## PIC16(L)F1826/1827 Family Silicon Errata and Data Sheet Clarification

The PIC16(L)F1826/1827 family devices that you have received conform functionally to the current Device Data Sheet (DS41391D), except for the anomalies described in this document.

**FIGURE 1: INSTRUCTION CYCLE DELAY CALCULATION EXAMPLE**

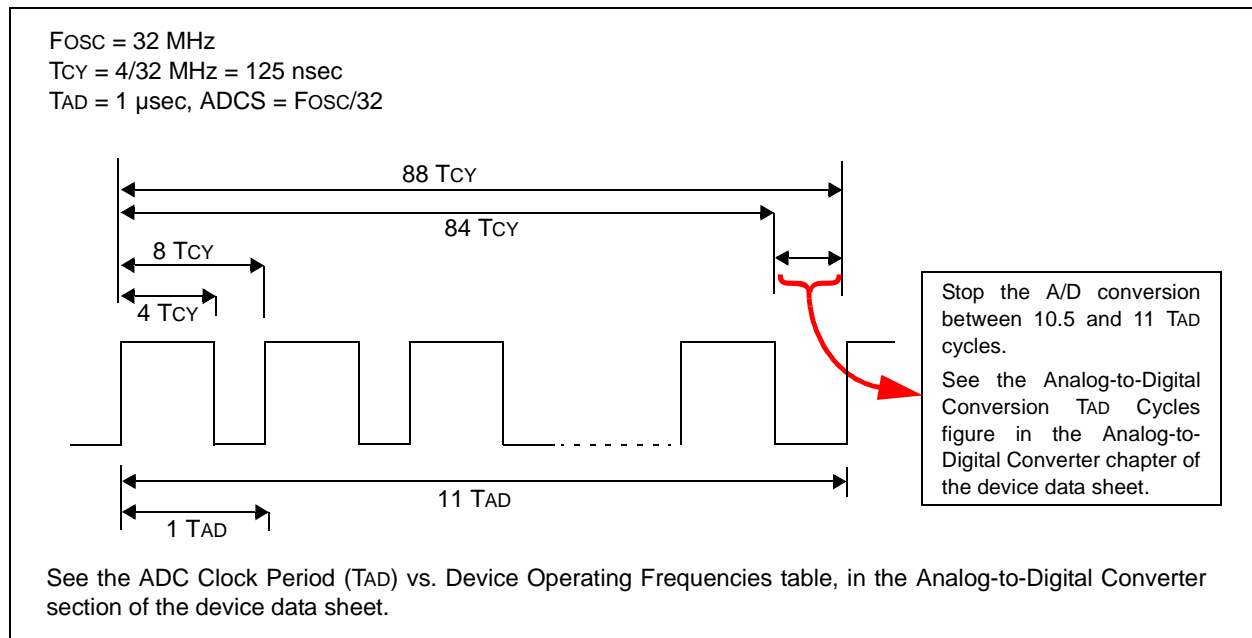
An ADC conversion may not complete under these conditions:

1. When  $F_{OSC}$  is greater than 8 MHz and it is the clock source used for the ADC converter.
2. The ADC is operating from its dedicated internal FRC oscillator and the device is not in Sleep mode (any  $F_{OSC}$  frequency).

When this occurs, the ADC Interrupt Flag (ADIF) does not get set, the  $\overline{GO/DONE}$  bit does not get cleared, and the conversion result does not get loaded into the ADRESH and ADRESL result registers.

Method 3: This method is provided if the application cannot use Sleep mode and requires continuous operation at frequencies above 8 MHz. This method requires early termination of an ADC conversion. Provide a fixed time delay in software to stop the A-to-D conversion manually, after all 10 bits are converted, but before the conversion would complete automatically. The conversion is stopped by clearing the  $\overline{GO/DONE}$  bit in software. The  $\overline{GO/DONE}$  bit must be cleared during the last  $\frac{1}{2}$  TAD cycle, before the conversion would have completed automatically. Refer to [Figure 1](#) for details.

In [Figure 1](#), 88 instruction cycles ( $T_{CY}$ ) will be required to complete the full conversion. Each TAD cycle consists of 8  $T_{CY}$  periods. A fixed delay is provided to stop the A/D conversion after 86 instruction cycles and terminate the conversion at the correct time as shown in the figure above.

**Note:** The exact delay time will depend on the TAD divisor (ADCS) selection. The Tcy counts shown in the timing diagram above apply to this example only. Refer to [Table 3](#) for the required delay counts for other configurations.
